STAFF REPORT

FILE NO: 3220-GibsonsWay-835

SUBJECT: Development Variance Permit (DVP-2022-06) and Form and Character Development Permit (DP-2022-26) for a proposed mixed-use building at 835 Gibsons Way

Figure 2: Access points to the proposed development.

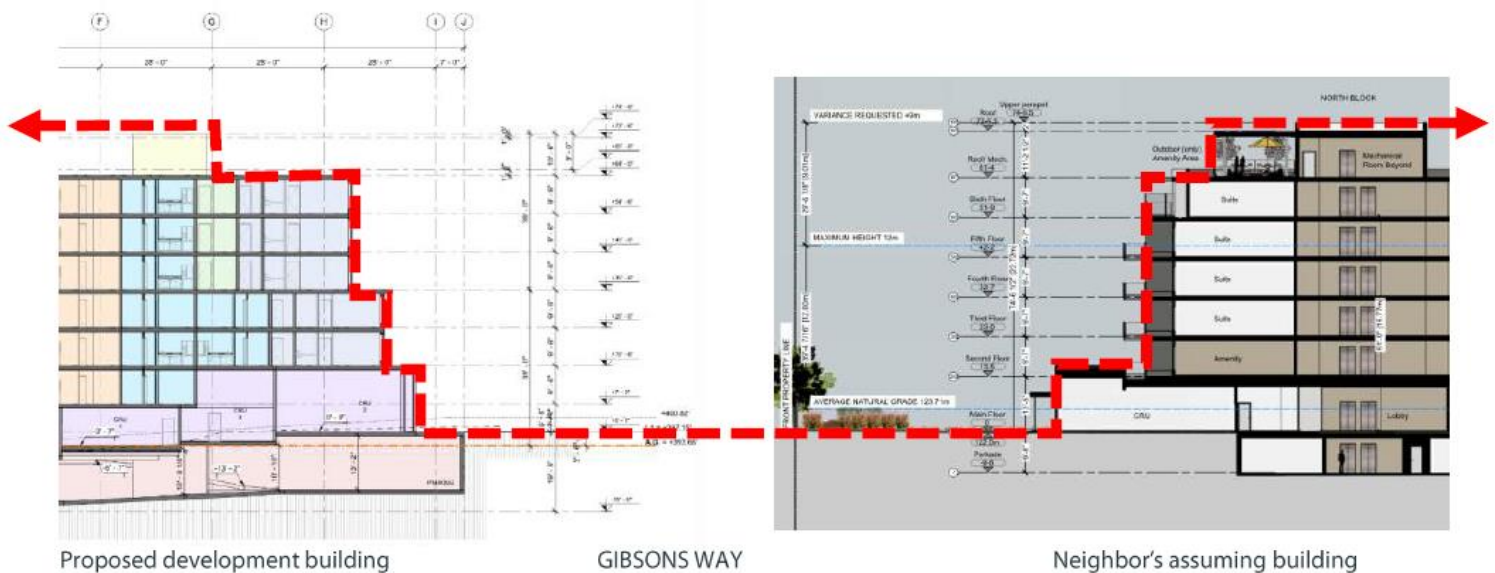
The building is proposed to be 6-storeys from Gibsons Way and 7-storeys from the rear, looking at the building from Farnham Road. Vehicular access to the site will be from Farnham Road and the residential lobby will also be accessed from Farnham Road, as shown in Figure 2.

Figure12: Image showing the east elevation along Farnham Road

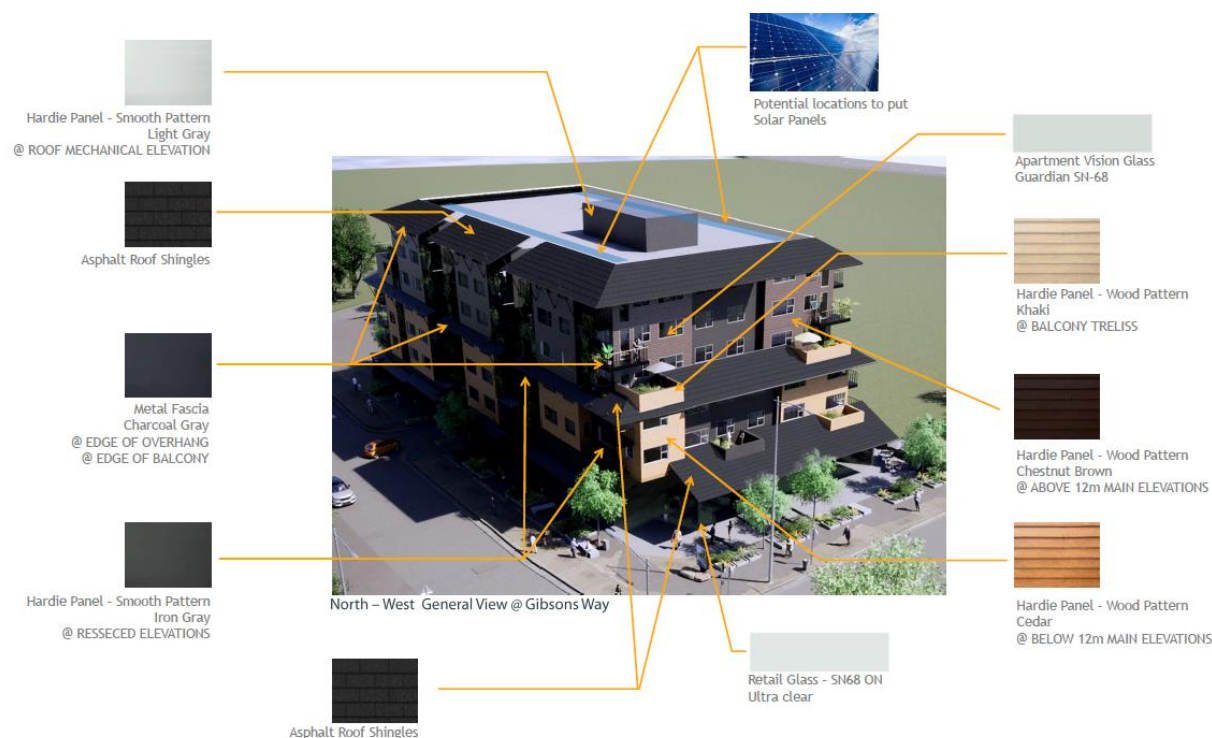
Window treatments have been changed and made smaller, resulting in an increase of hardi-board material which in turn creates a darker and heavier looking building. Railings have been changed to metal railings rather than glass in option 1.

The west elevation has been redesigned, to limit overlook to the neighbouring property. The resulting changes create an older character building rather than the west coast modern look of option 1.

Massing remains unchanged with the building stepping back at the third level on Gibsons Way, as well as at the rear.
